Origination Form
Proposed Revisions to a Standard Plans Index

Originator:	Caldwell, Carey Allie	Index Number:	711-002
Date:	5/6/2026	Sheet Number(s):	1, 2
E-mail:	carey.caldwell@dot.state.fl.us	Index Title:	Bicycle Markings

LAST REVISION 11/01/26	REVISION	DESCRIPTION:	 FY 2027-28 STANDARD PLANS	BICYCLE MARKINGS	INDEX 711-002	SHEET 1 of 2
------------------------------	----------	--------------	--	------------------	------------------	-----------------

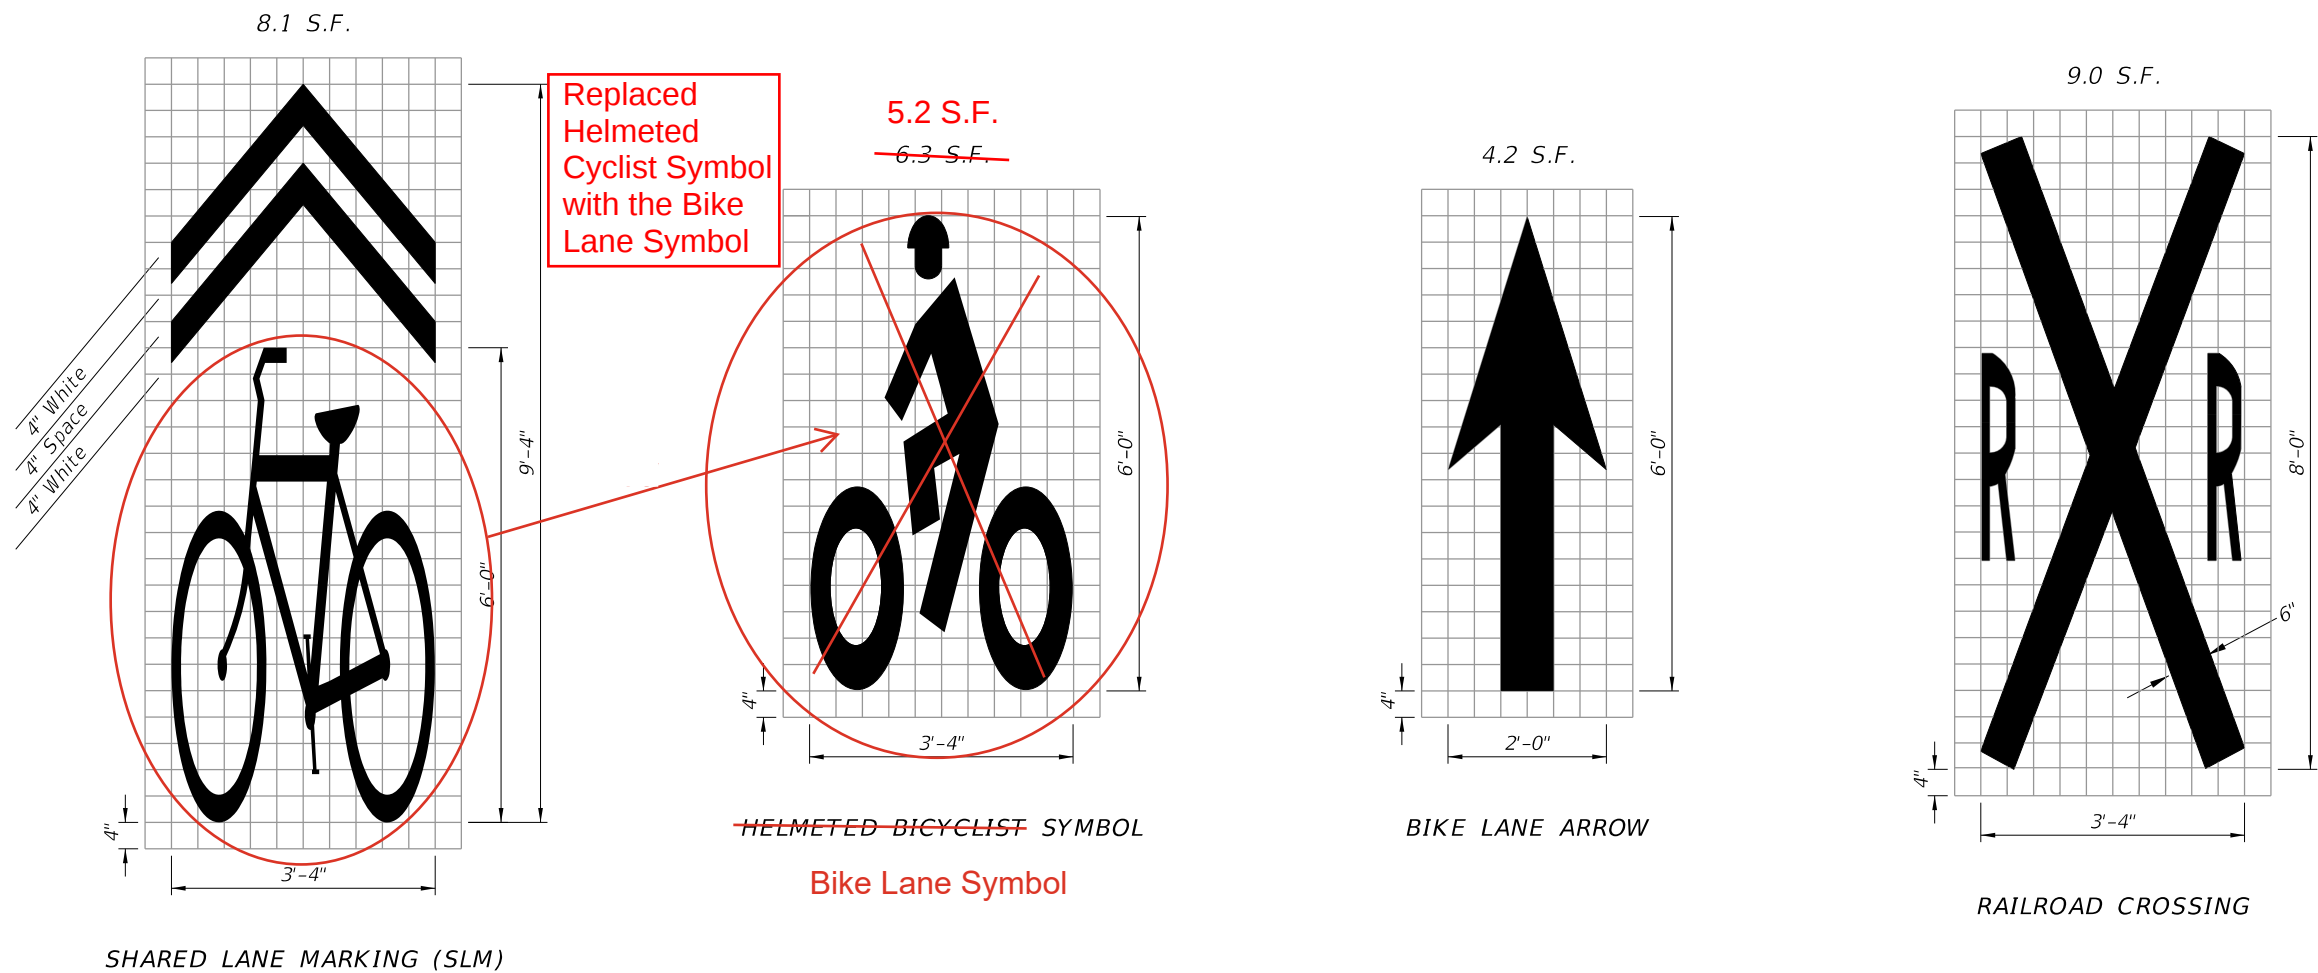
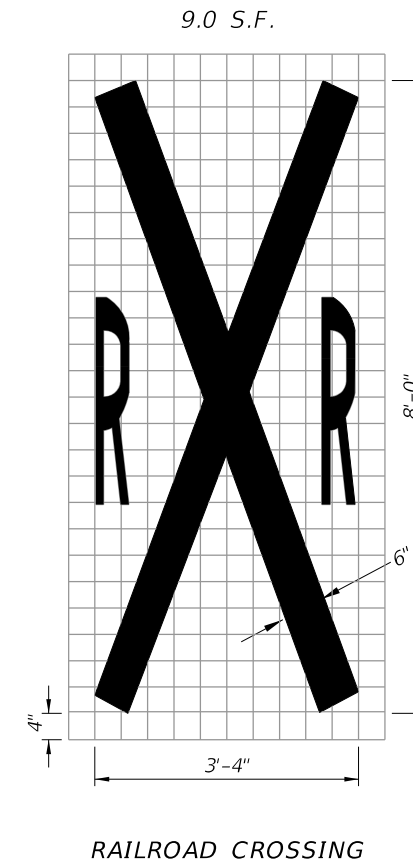
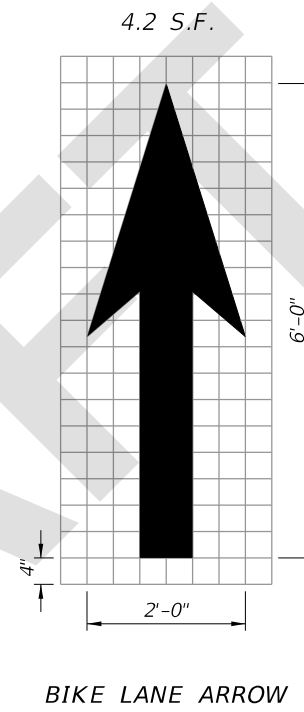
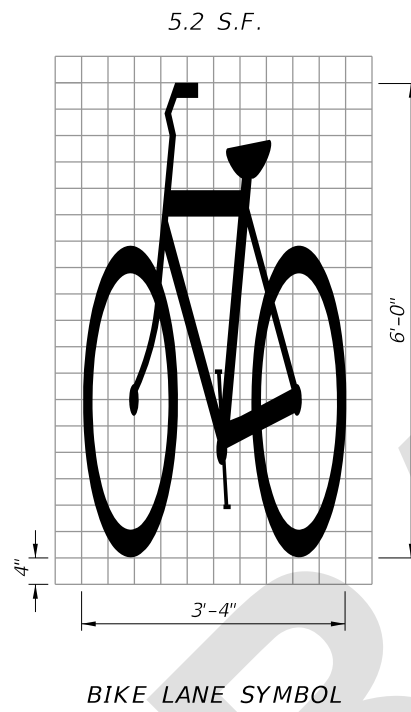
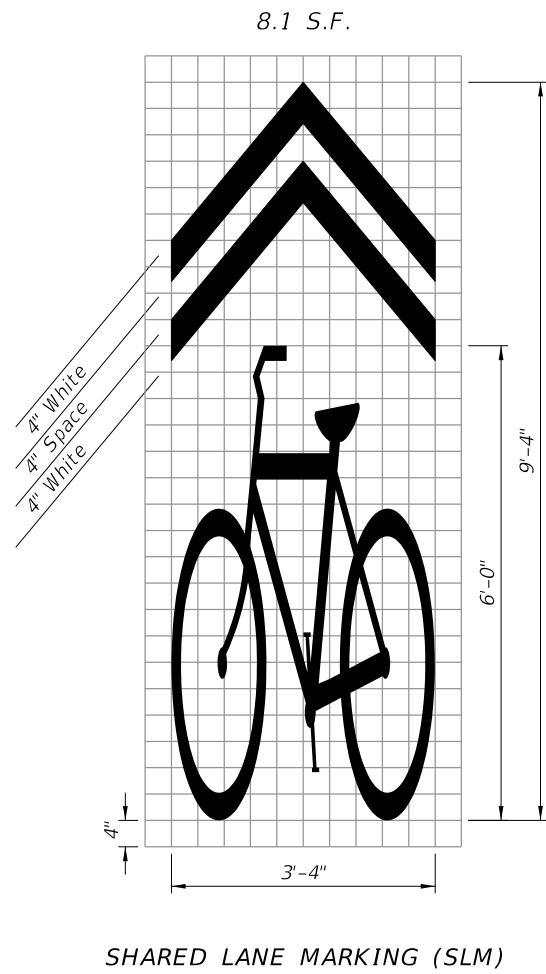
All: Updated bike lane symbols

MUTCD 11th Edition has removed the helmeted bicyclist symbol and therefore all FDOT Standards and Criteria must be updated accordingly.
